DATE: 1.06.2016
TO: ProTrak
FROM: Bill McDow
Transportation Planning

■ **MAYFAIRE TOWN CENTER PHASE 3 [TRC Plan Review]**

↻ Initial Review Note ↻

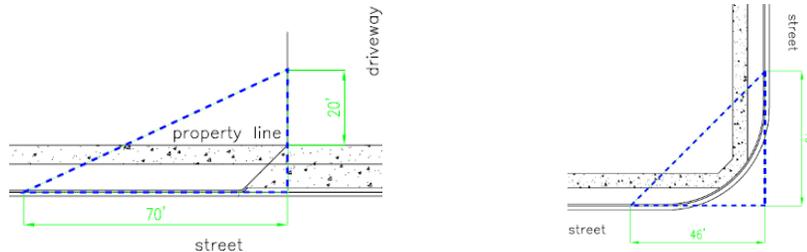
1. Show a cross-section detail showing the existing street and the proposed changes to the cross-section detail.
2. Install wheelchair ramps at the corner of Town Center Drive and the new/revised crosswalks per City standards. Connect sidewalk with the ramps.
3. All on street parking shall be at least 15' from fire hydrants, please verify distance on the site plan and utility plan.
